# UNITED STATES PATENT AND TRADEMARK OFFICE

APPLICATION NO.	FILING DATE	FIRST NAMED INVENTOR	ATTORNEY DOCKET NO.	CONFIRMATION NO.
09/966,427	09/28/2001	Harini V. Sundaresan	TI-31767	6354
23494	7590	07/06/2005	EXAMINER	
TEXAS INSTRUMENTS INCORPORATED P O BOX 655474, M/S 3999 DALLAS, TX 75265			TORRES, JUAN A	
			ART UNIT	PAPER NUMBER
			2631

## Office Action Summary

## DETAILED ACTION

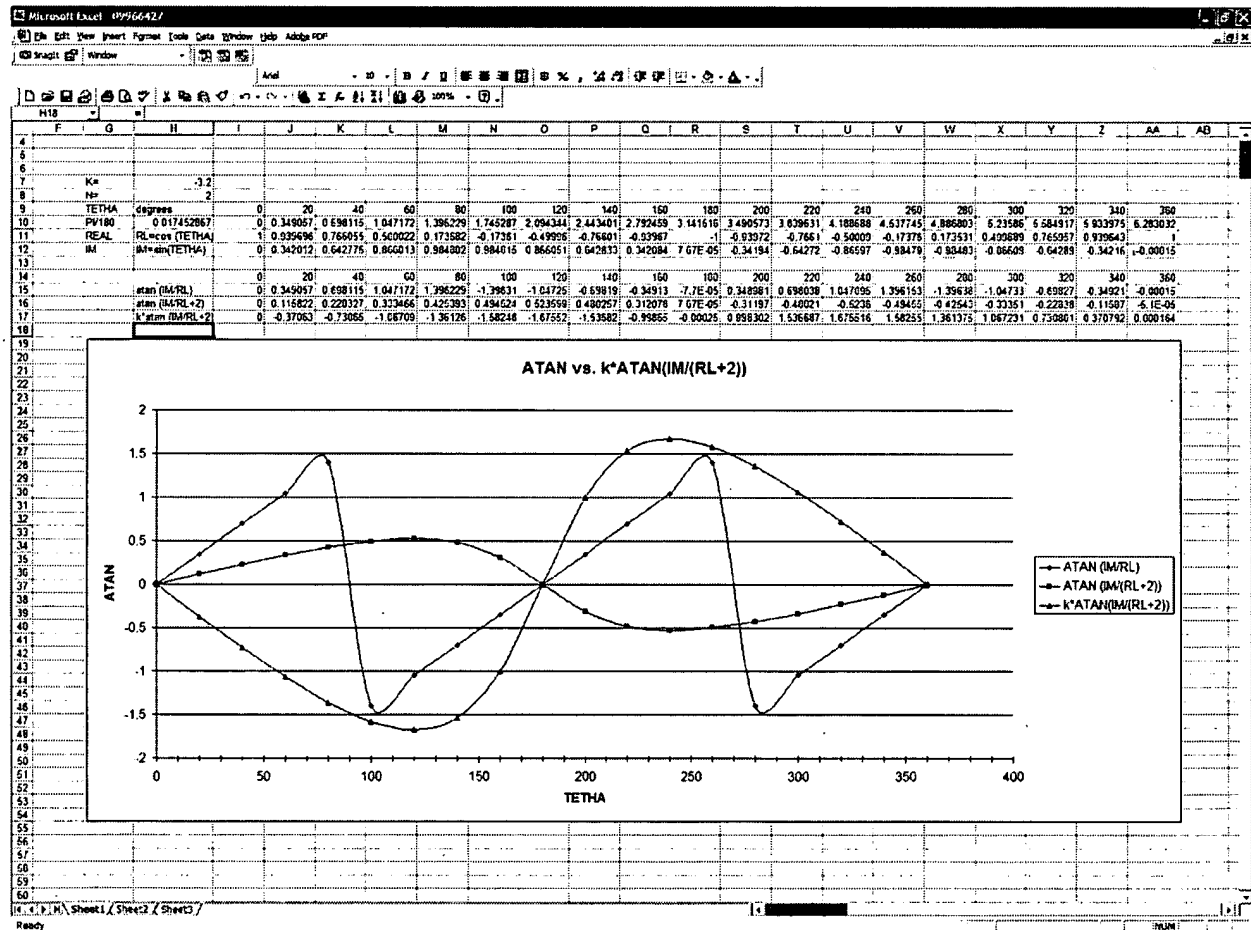
The Applicant contends, "This corresponds substantially to the graphs of Figures 5 and 6 of this application. Note further that the claims do not recite that the factor K is 7. Instead this application teaches how to determine the factor K at page 13, lines 3 to 8. The above example is plotted with a factor K of -3.2."

The Examiner disagrees and asserts, that, as indicated in the previous Office the specification clearly states (page 13 lines 3-8) that:" Further, referring to Figures 5 and 6, assuming the value of N is chosen to be 2, there is an overall reduction of amplitude of the demodulated signal by a factor K that is substantially uniform. In the example illustrated in Figures 5 and 6, the factor K was simply determined by taking the ration of the amplitude of curve 50 and curve 52 at peak 53. That is,  $K = \max((idealBBMUX)/\max(scaledBBMUX))$ . This ratio was calculated to be approximately 7.

Also if the value of  $k$  is chose equal to  $-3.2$  the comparison still is not persuasive, because the results are even worse:

K=	-3.2																
N=	2																
TETHA	degrees	0	20	40	60	80	100	120	140	160	180	200	220	240	260	280	
PI/180	0.017452867	0	0.349057	0.698115	1.047172	1.396229	1.745287	2.094344	2.443401	2.792459	3.141516	3.490573	3.839631	4.188688	4.537745	4.886803	
REAL	RL=cos(TETHA)	1	0.939696	0.766055	0.500022	0.173682	-0.17361	-0.49996	-0.76601	-0.93967	-1	-0.93972	-0.7661	-0.50009	-0.17376	0.173531	
IM	IM=sin(TETHA)	0	0.342012	0.642775	0.866013	0.984802	0.984815	0.866051	0.642833	0.342084	7.67E-05	-0.34194	-0.64272	-0.86597	-0.98479	-0.98483	
		0	20	40	60	80	100	120	140	160	180	200	220	240	260	280	
atan (IM/RL)		0	0.349057	0.698115	1.047172	1.396229	-1.39631	-1.04725	-0.69819	-0.34913	-7.7E-05	0.348981	0.698038	1.047095	1.396153	-1.39638	
atan (IM/RL+2)		0	0.115822	0.228327	0.333466	0.425393	0.494524	0.523599	0.480257	0.312078	7.67E-05	-0.31197	-0.48021	-0.5236	-0.49455	-0.42543	
k*atan (IM/RL+2)		0	-0.37063	-0.73065	-1.06709	-1.36126	-1.58248	-1.67552	-1.53682	-0.99865	-0.00025	0.998302	1.536687	1.675516	1.58255	1.361375

For these reasons and the reason stated en the previous Office Action, the rejection of claims 1-10 is maintained.

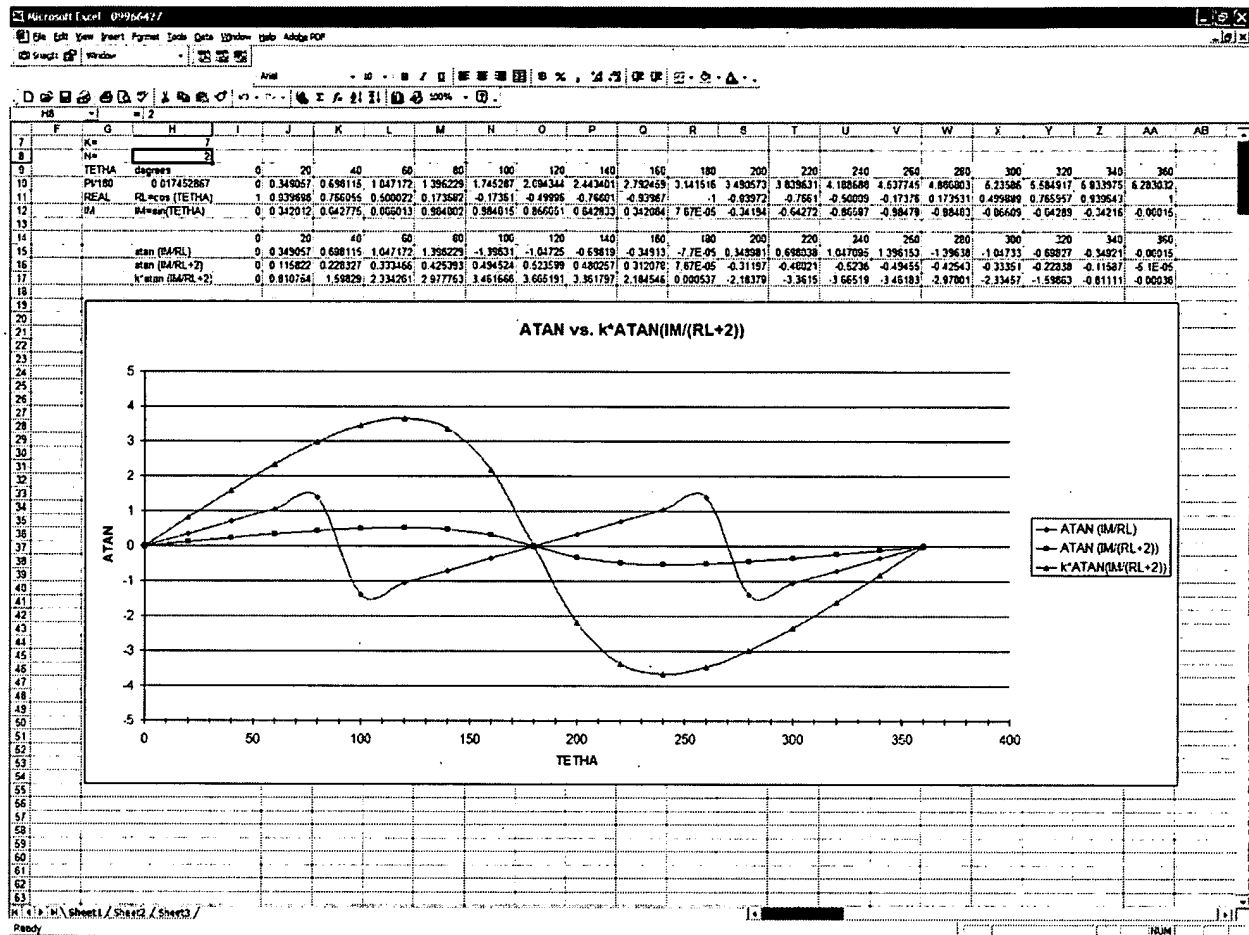
Claims 1-10 rejected under 35 U.S.C. 101 because the disclosed invention is inoperative and therefore lacks utility. The disclosure present a method for computing the value of arctangent (IM/RL) using the alternative formula  $7 \cdot \arctangent (IM/(RL+2))$  (see original specification page 13 lines 3-8) in all the values of the imaginary part ( $IM = \sin(\theta)$ ), and the real part ( $RL = \cos(\theta)$ ). The following graphic is a representation of the two values of arctangent (IM/RL) and  $7 \cdot \arctangent (IM/(RL+2))$  (in the OY axes) for  $\theta = 0$  to  $\theta = 360$  is steps of 20 degrees:

K=																	7
N=																	2
TETHA	degrees																
PI/180	0.017452867	0	0.349057	0.698115	1.047172	1.396229	1.745287	2.094344	2.443401	2.792459	3.141518	3.490573	3.839631	4.188688	4.537745	4.886803	
REAL	RL=cos (TETHA)	1	0.939696	0.766055	0.500022	0.173682	-0.17361	-0.49996	-0.76601	-0.93967	-1	-0.93972	-0.7661	-0.50009	-0.17378	0.173531	
IM	IM=sin(TETHA)	0	0.342012	0.642775	0.866013	0.984802	0.984815	0.866051	0.642833	0.342084	7.67E-05	-0.34194	-0.64272	-0.86597	-0.98479	-0.98483	
		0	20	40	60	80	100	120	140	160	180	200	220	240	260	280	
atan (IM/RL)		0	0.349057	0.698115	1.047172	1.396229	-1.39631	-1.04725	-0.69819	-0.34913	-7.7E-05	0.348981	0.698038	1.047095	1.396153	-1.39638	
atan (IM/RL+2)		0	0.115822	0.228327	0.333466	0.425393	0.494524	0.523599	0.480257	0.312078	7.67E-05	-0.31197	-0.48021	-0.5238	-0.49455	-0.42543	
k*atan (IM/RL+2)		0	0.810754	1.59829	2.334261	2.977753	3.461666	3.665191	3.361797	2.184546	0.000537	-2.18379	-3.3615	-3.66519	-3.46183	-2.97801

It is evident that the approach is not good at all. The proposed claims lack of utility in the full range of the disclosure.
